33 FITZROY SQUARE  
LONDON W1T 6EU

**Appendix 4**

**Pre-Application Advice Letter, April 2015**

Town and Country Planning Act 1990 (as amended)  
**RESPONSE TO ENQUIRY, REFERENCE 2015/1125/PRE**  
**33 Fitzroy Square, London, W1T 6EU**

HISTORICAL DEVELOPMENT THIRD FLOOR PLANS	<b>054</b>	-
SHEET NO.	REVISION

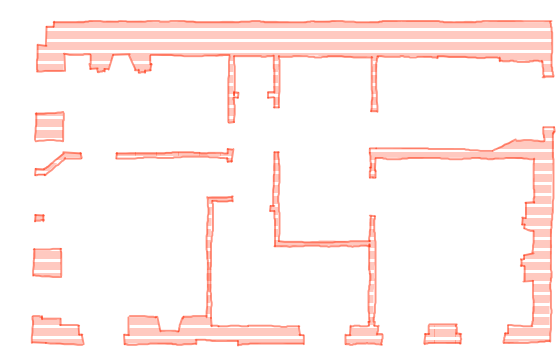
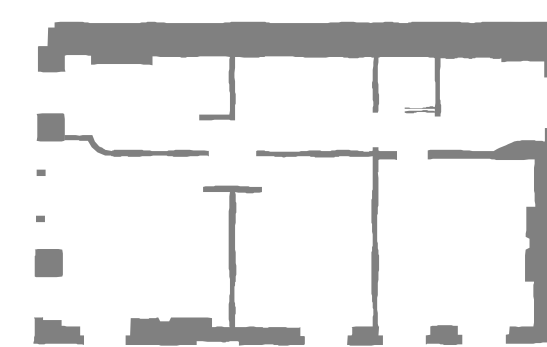
At 3<sup>rd</sup> floor level a new partition is to be inserted into the front room. This is likely to be acceptable. The proposed plans mark many of the partitions in red (new), although it appears that they are in the same position as the existing walls. Original and historic fabric should be retained wherever possible.

On the third floor, you propose a partition wall, meting the front wall behind the mullion of the Diocletian window. This is likely to be acceptable. Elsewhere, your strategy for reorganisation of spaces is acceptable in restricting alterations to modern fabric, much dating from the scheme consented in 2006, and concentrating new partitions for service spaces on the lower floors within the annex rather than within the historic room volumes of the main house.
